Assessment report to Sydney Central City Planning Panel

PPS-2018SWC100

DA number	SPP-18-01547	Date of lodgement	10 August 2018
Applicant	Poly Australia c/- Mecone		
Owner	Cudgegong 048 Services Pty Ltd		
Proposed development	Demolition of existing structures and construction of a multi dwelling housing development comprising 91 x 3 storey dwellings, strata subdivision and associated car parking, landscaping and drainage works		
Street address	Lots 1 & 2 DP 1241790 Macquarie Road, Rouse Hill (originally Lot 82 DP 208203)		
Notification period	5 to 19 September 2018	Number of submissions	0 during exhibition periods, but 1 late submission

Figure 1 - Condition 6.9.4 and approved subdivision plan

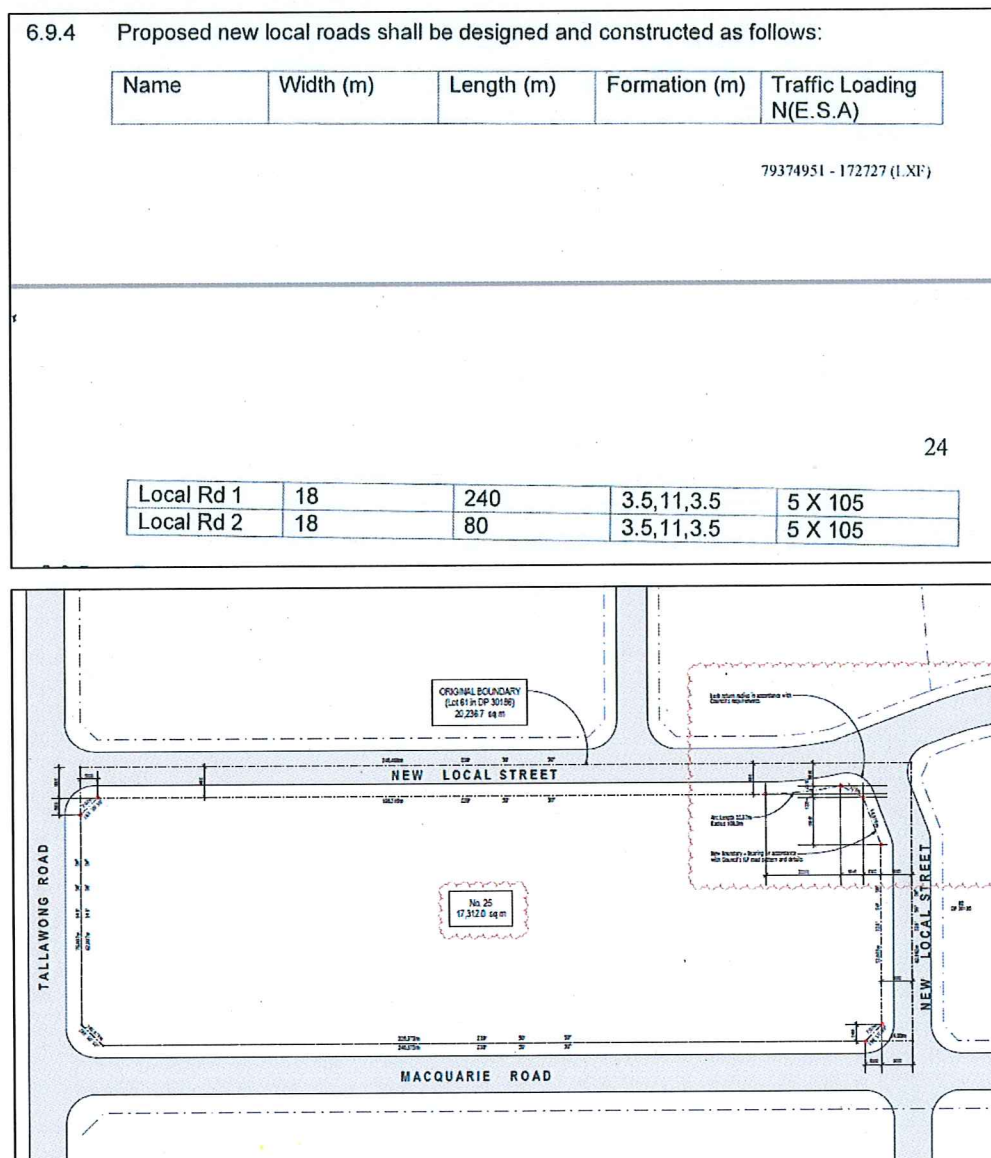
- 8.5 Condition 6.9.4 imposed on SPP-16-04466 approved by the NSW Land and Environment Court requires the developer of 25 Macquarie Road to build a full new local road as per the approved plan (see Figure 1 below).

Figure 2 - Realignment of new local road between 25 Macquarie Road and subject site

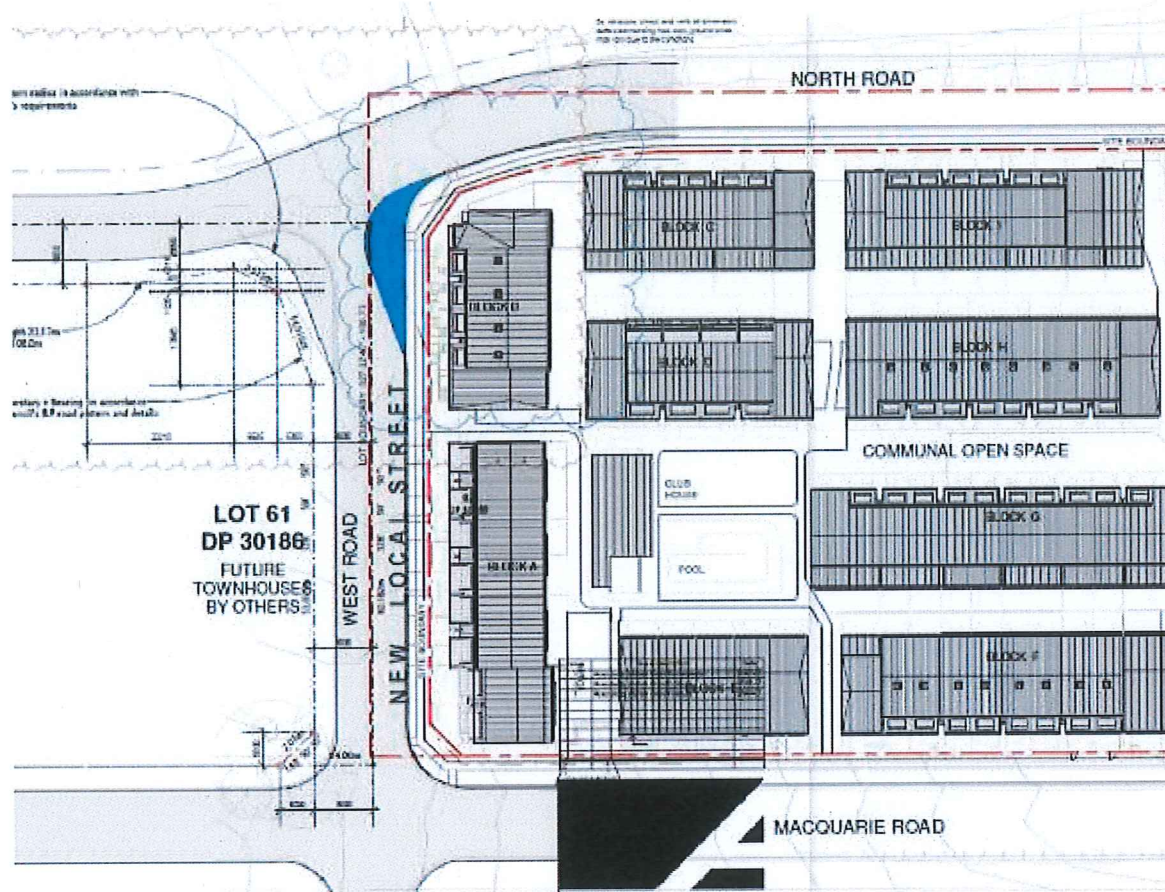
- 8.6 The realignment of the new local road between 25 Macquarie Road and this site is demonstrated in Figure 2 below. The area identified in blue demonstrates the realignment of the half road. An enlarged intersection is accommodated on the Applicant's land, with no impact on the approved DA at 25 Macquarie Road. It will require approval from Council's Manager Access and Transport and the Local Traffic Committee for the configuration, line marking and signage arrangements.
